White Bear Yard
Daylight Mark ups

24th March 2020

JAMESON HOUSE

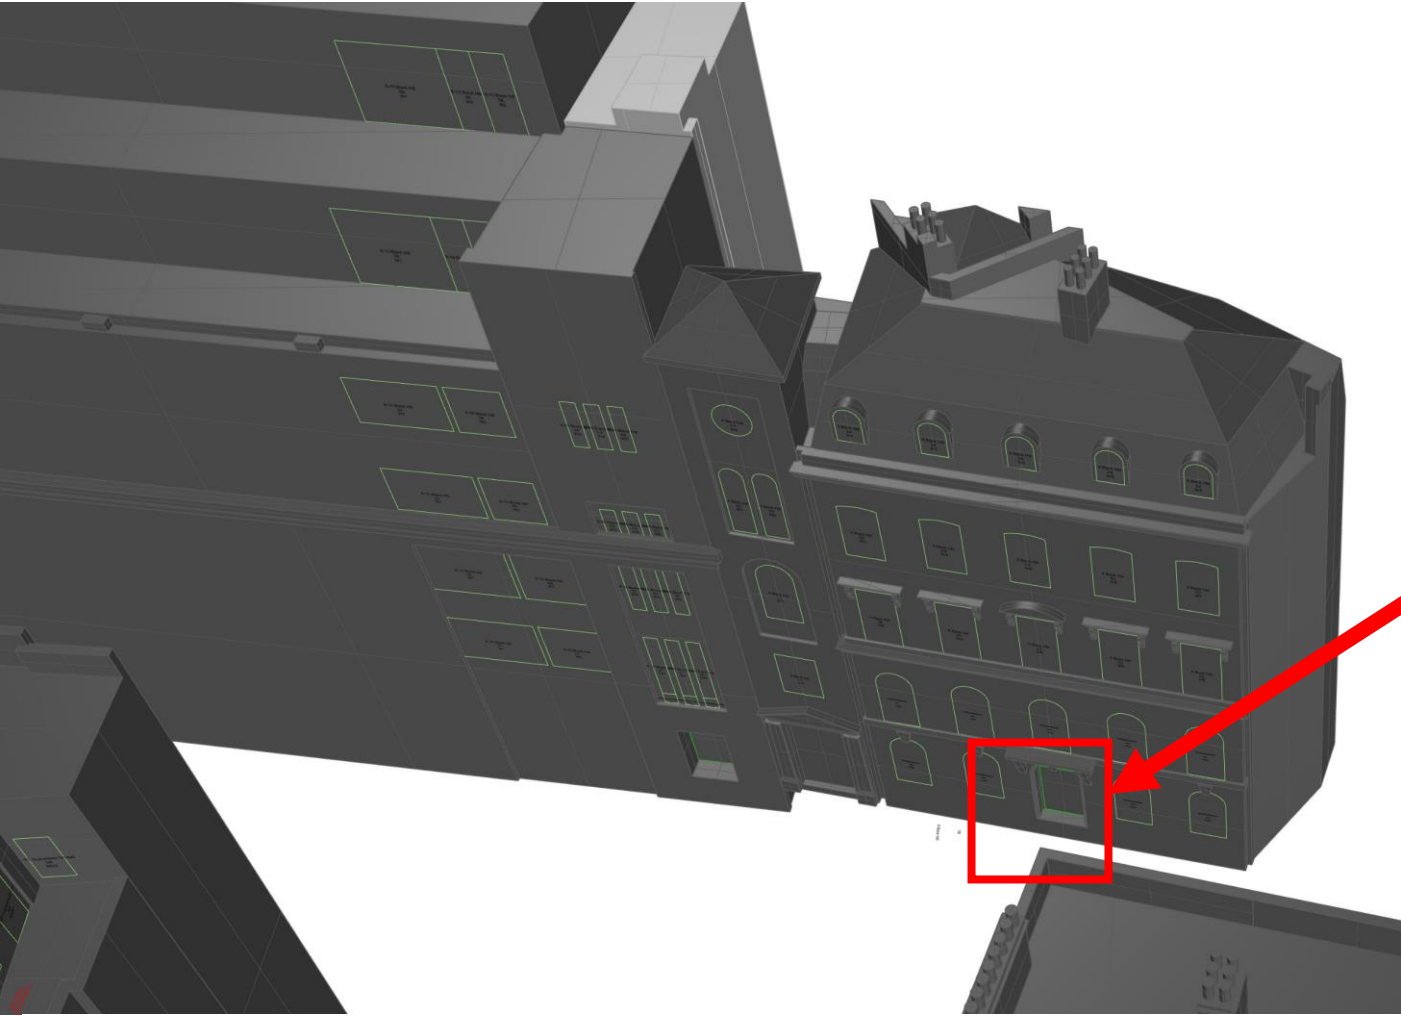
Existing View of the sky is limited by boundary wall, and ratio of impact is only marginally below the acceptable threshold (0.8).
